Agenda Item 8a
Bank Storage Withdrawal &
Aquifer Storage and
Recovery
Water Appropriation
Applications

Bank Storage Withdrawal Well Applications 45569 and 45572

Aquifer Storage and Recovery Well Application 45567

Generalized Lithology of Equus Beds Aquifer at Bank Storage Withdrawal Site, Sec. 8, T23S, R2W

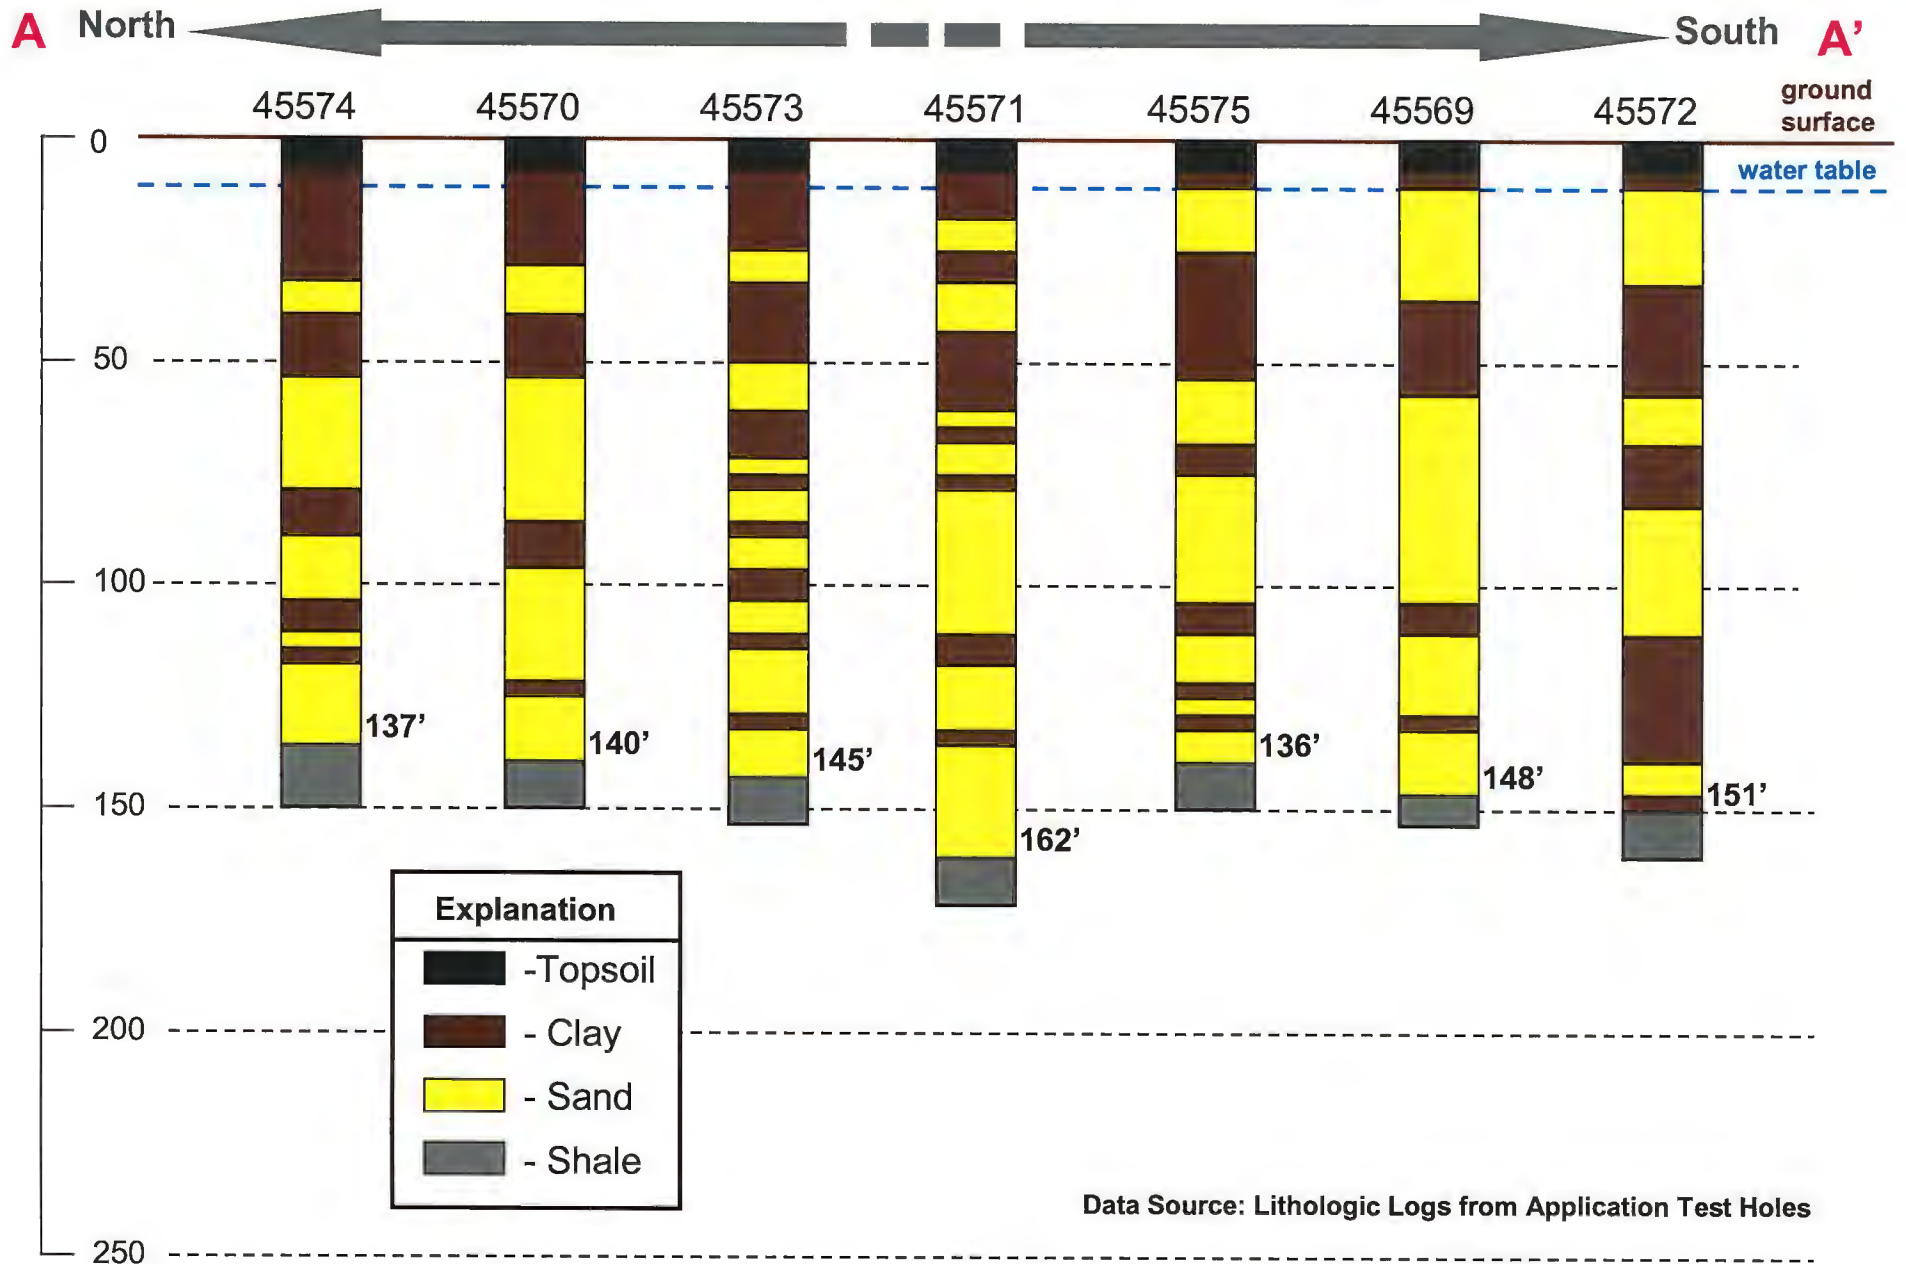
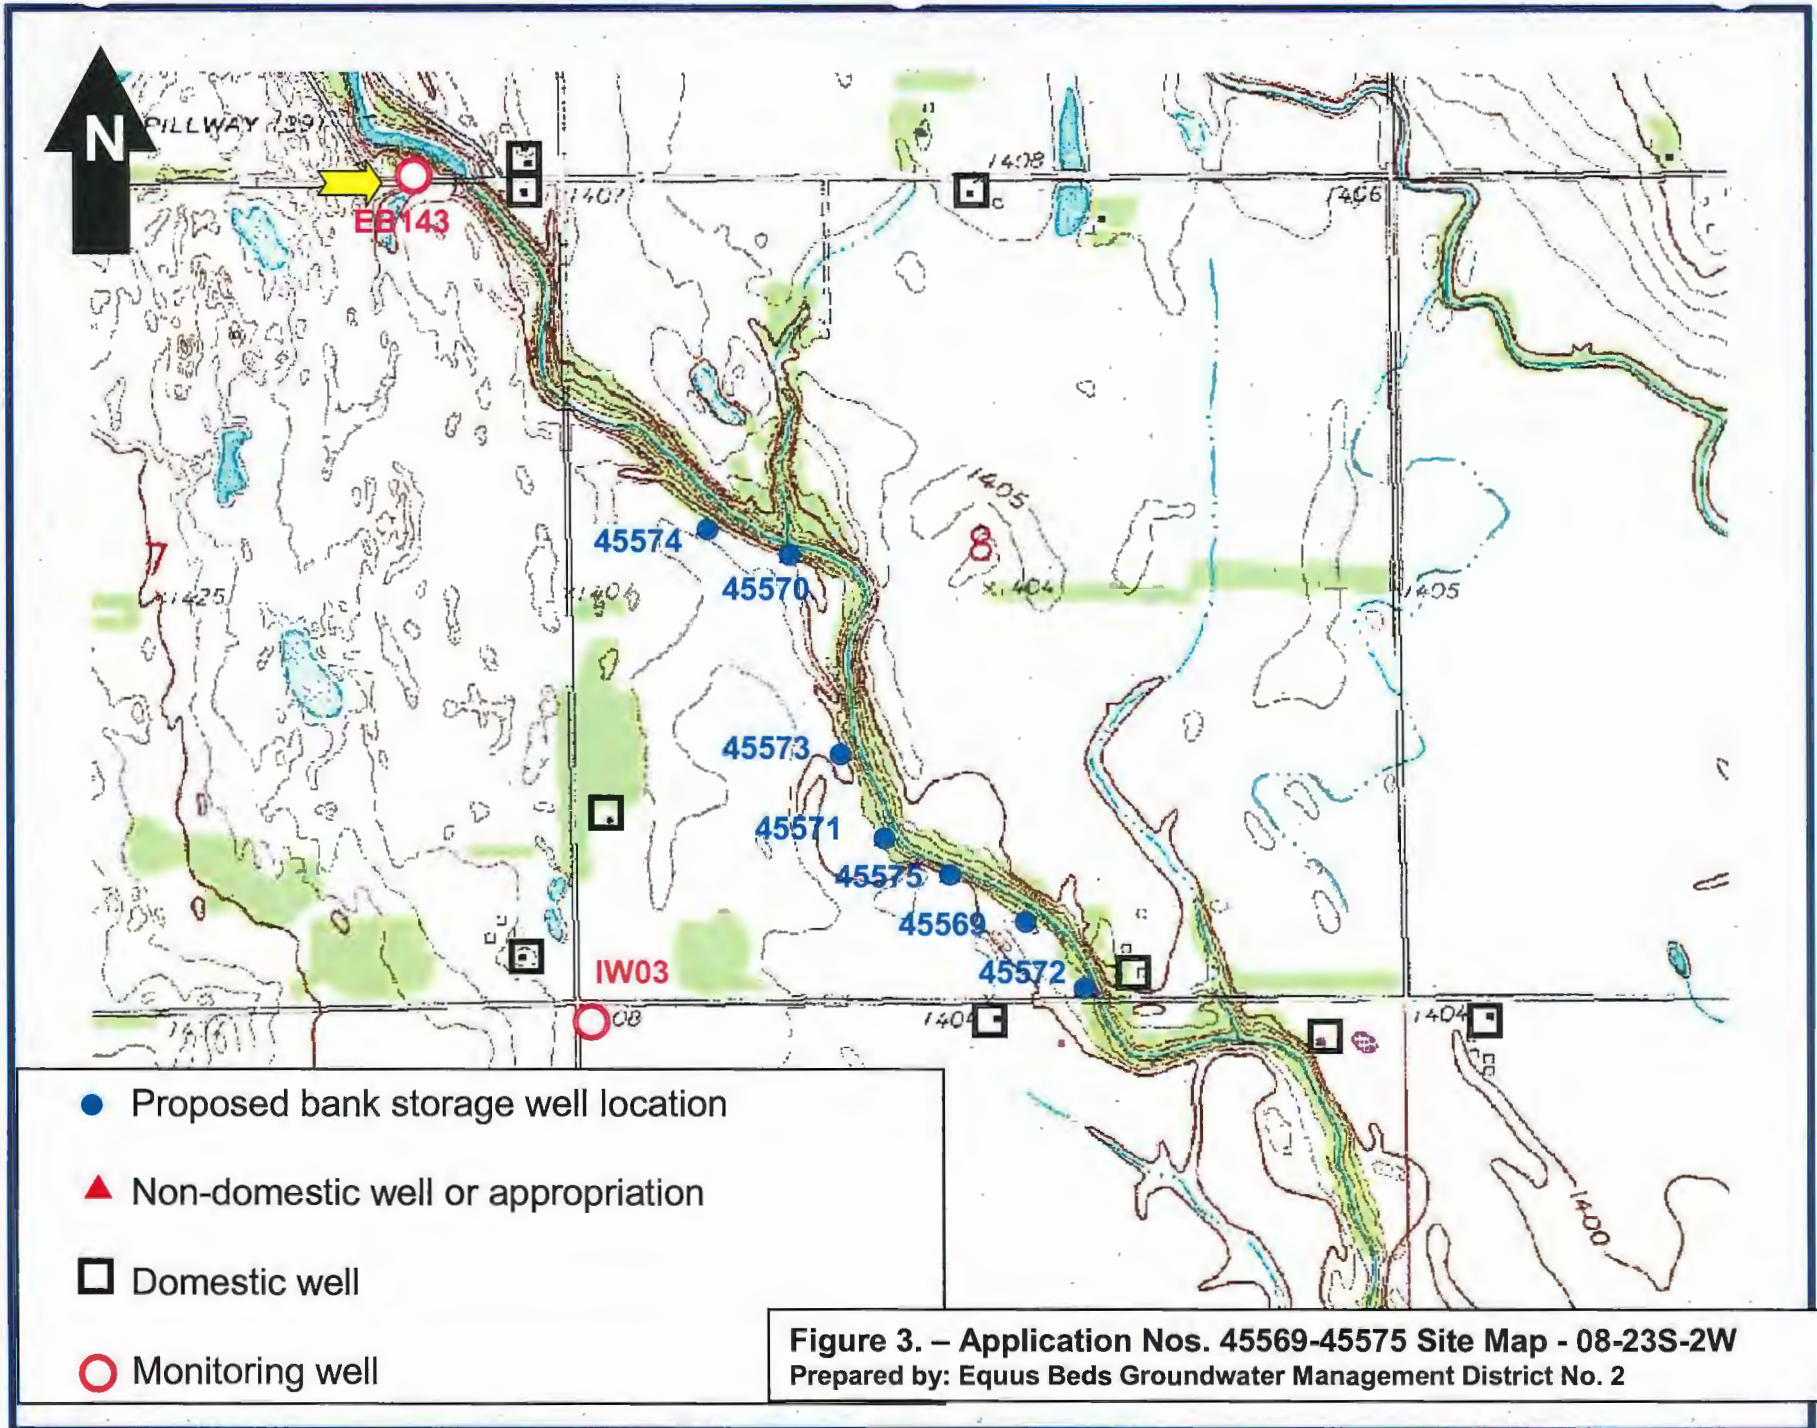
The City of Wichita is requesting the locations of the proposed points of diversions for applications 45569 and 45572 are moved to improve the quality of bank storage water diverted by the two bank storage wells.

Attachment 45567-A. – Application No. 45567 Site Map - NW 25-23S-3W
Prepared by: Equus Beds Groundwater Management District No. 2 - 07/06/04

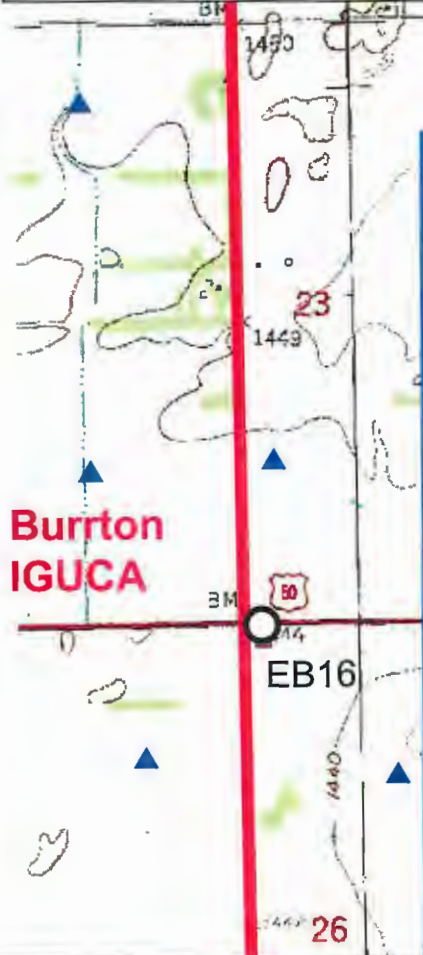
The City of Wichita is requesting the location of the proposed point of diversion for application 45567 is moved to about 200' north of the proposed point of diversion for site access.

- 1) Any future application for change in point of diversion filed on permit no. 45567, shall comply with the minimum well spacing requirements set forth in Well Spacing Rule and Regulation K.A.R. 5-22-2;
- (2) When it is determined by the Division of Water Resources that impairment of the existing prior rights, was caused by the applicant's well, the applicant agrees to either:
 - (a) regulate the well's diversion to secure water to satisfy the needs of a prior right; or
 - (b) any other requirement as specified by the Chief Engineer.
- (3) Subject to 30 approval conditions & MOU
- (4) Subject to reconfiguring the monitoring network

Operational Status
Limited to River
Flow Rate Minimum
42 cfs Apr-Sep
20 cfs Oct-Mar

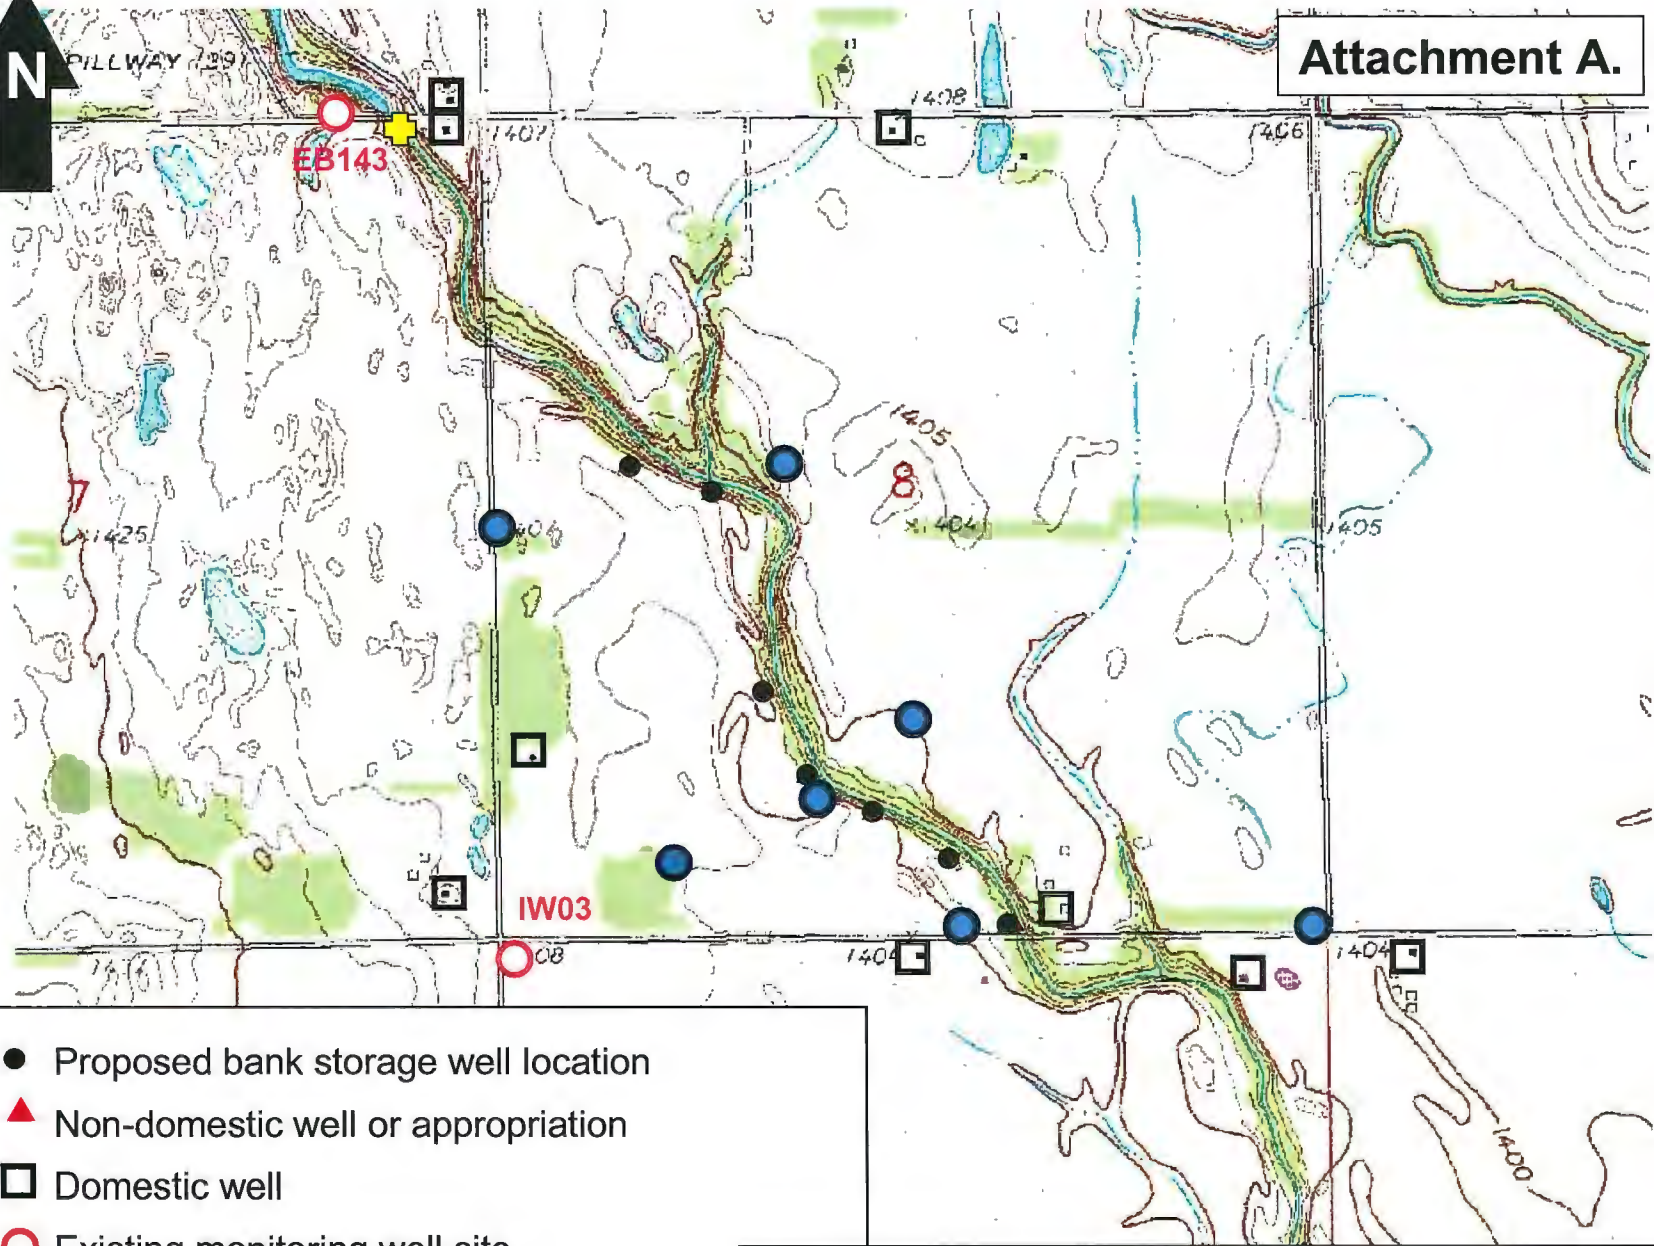
- 5. the withdrawal wells shall operate only during bank storage events in the Little Arkansas River, as determined by measured river flow and evidence correlating the increase of river stage to the increase of water level in the bank storage wells or adjacent monitoring wells;**
- 6. bank storage, for the purpose of permit conditions, is limited to flows in the Little Arkansas River equal to or greater than 20 cfs during the months of October through March, and 42 cfs during the months of April through September;**

- 7. streamflow data utilized to determine flow conditions and bank storage well utilization shall be collected from the USGS Halstead gage site located at Highway 50, and from an upstream gage site to be established under the same parameters as the Halstead gage site;**
- 8. the upstream streamflow gaging station shall be installed between one-half mile and one mile of the northernmost bank storage well (identified as DW-7);**

Attachment A. – Application No. 45570 Site Map - NW 08-23S-2W
Prepared by: Equus Beds Groundwater Management District No. 2 - 07/06/04

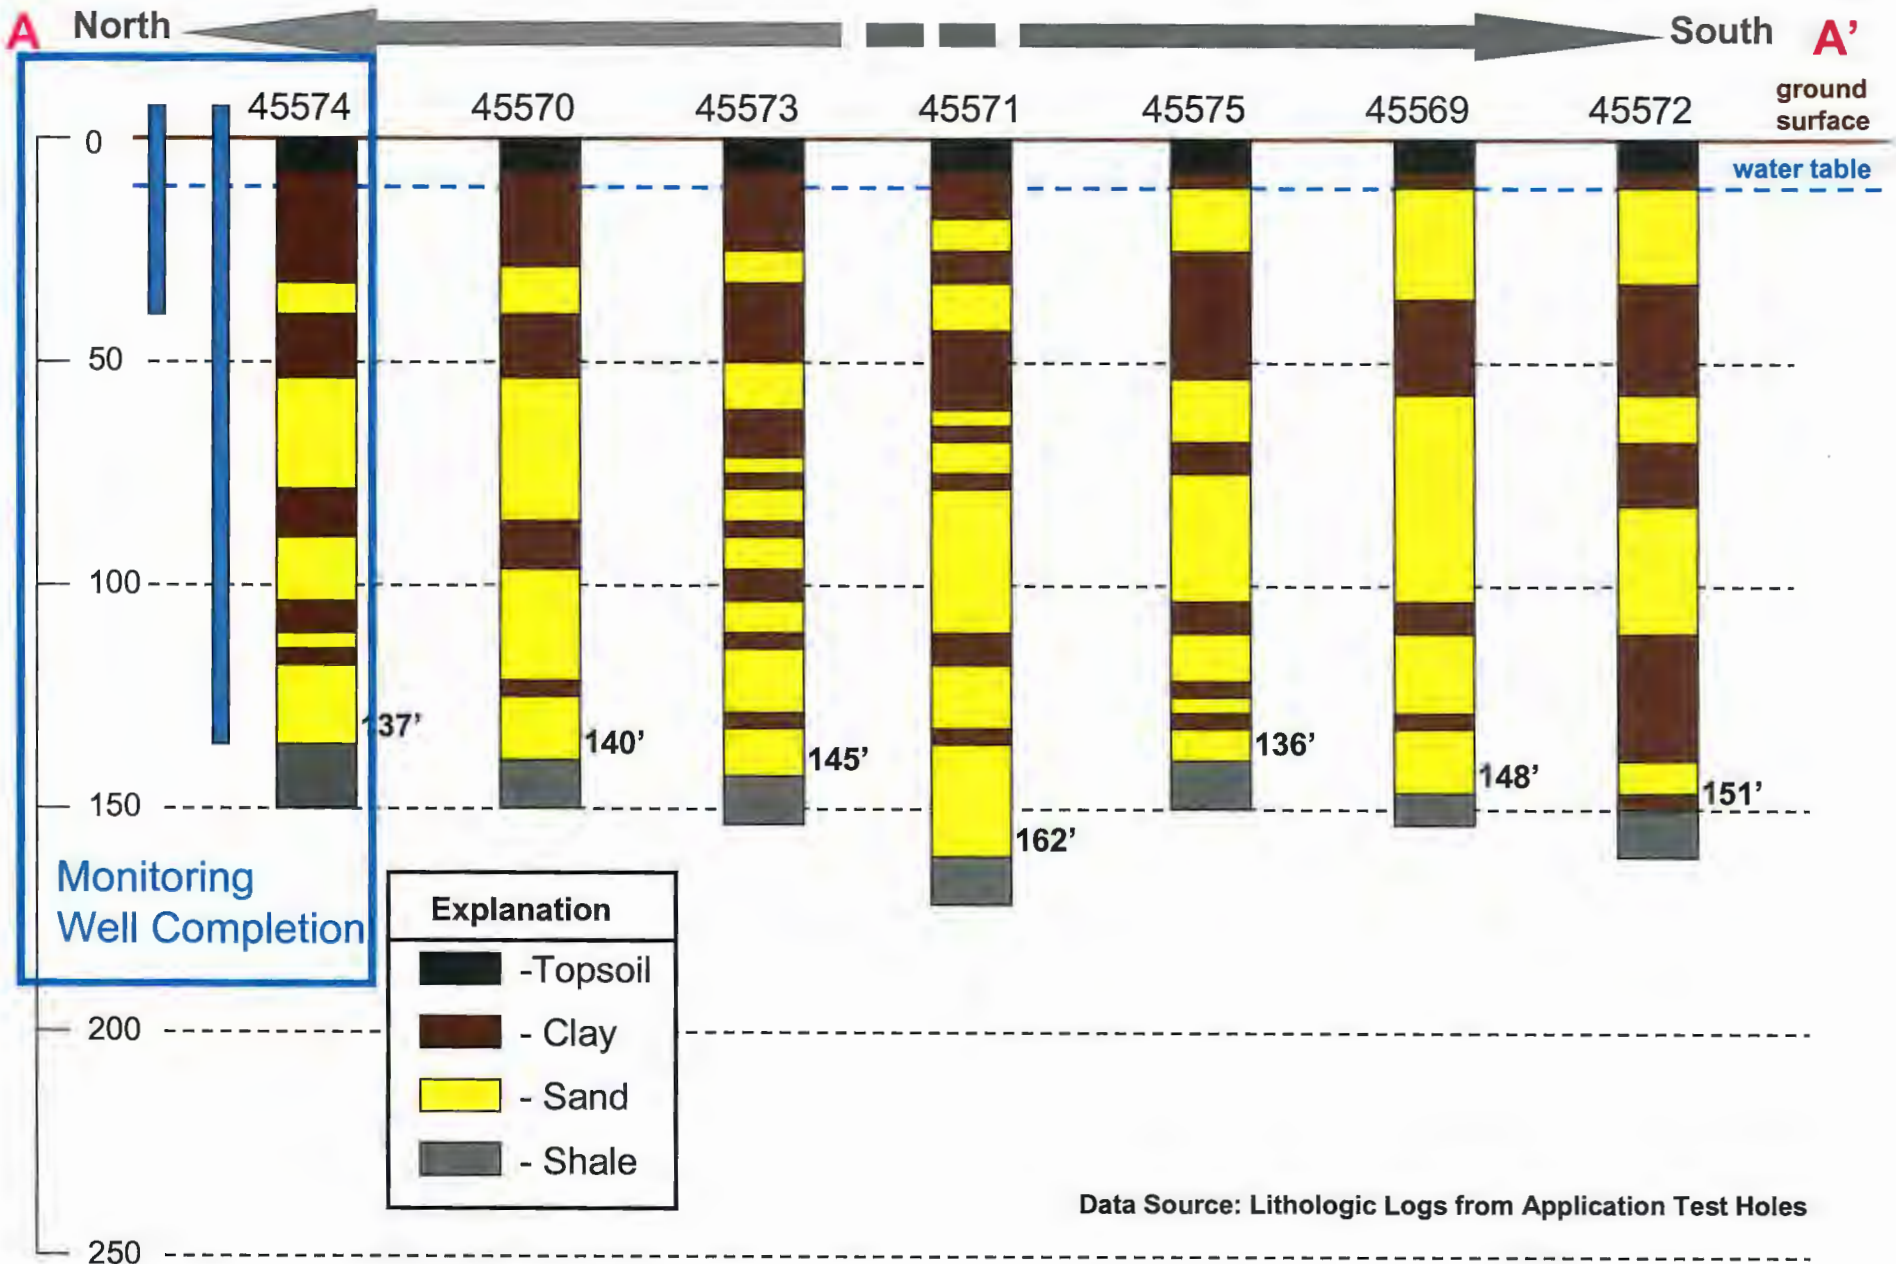
- 9. a monitoring well network is completed at the bank storage pump site as shown on Attachment A, and shall include existing monitoring well sites IW03, EB143 and EB144;**
